PLANNING APPLICATION PLA/2022/107 – VISTOR ACCOMMODATION (TWENTY UNITS) – ASSESSMENT REPORT (Ref: DOC/23/11227)

The purpose of this report is for Council to determine a planning application submitted by 6ty Degrees for the use and development of twenty visitor accommodation units at 429 Waterhouse Road Bridport.

Figure 3.4: Coastal Inundation Hazard Bands overlay (tl

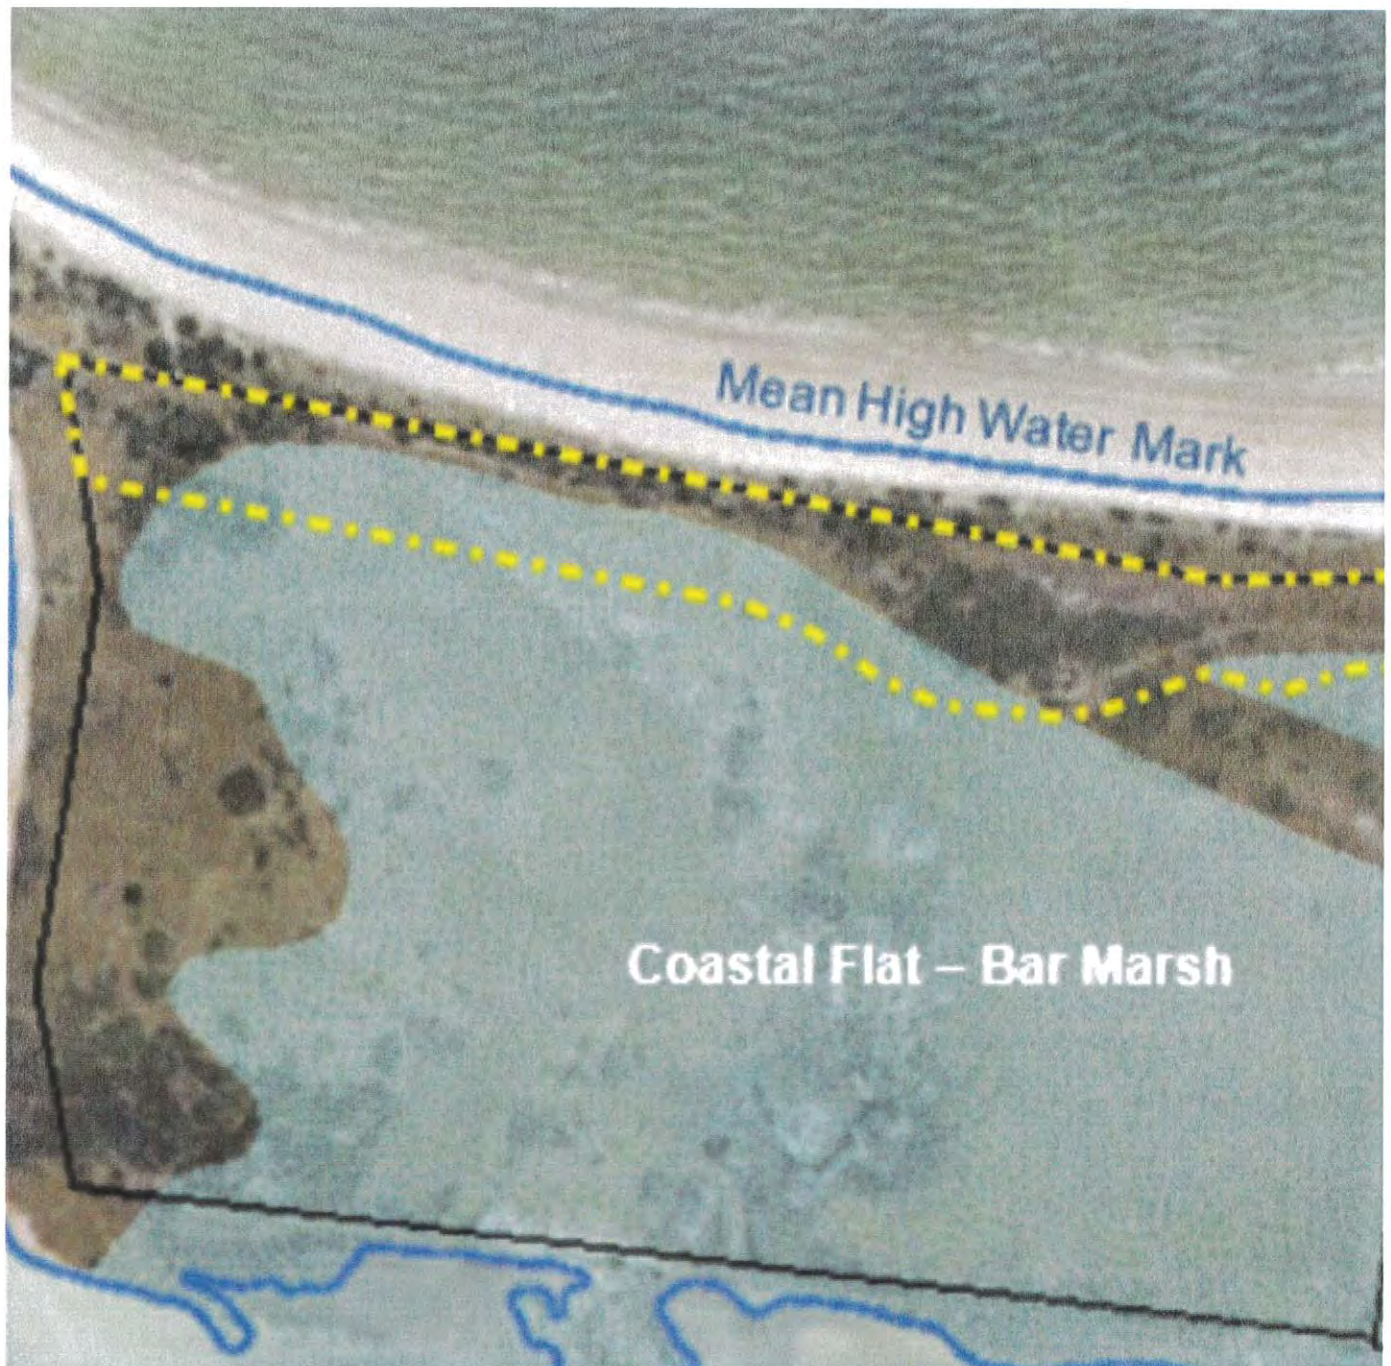
The building site is clearly at risk of coastal erosion as well as inundation, as Burbury Consulting reports and the diagrams below illustrate. This risk of building on mobile soft sediments will likely increase exponentially as the effects of sea level rise and extreme weather events become more evident. How could it possibly be either responsible or allowable to site and approve these habitations at the proposed location? The Infrastructure is at risk from both the seaward and below.
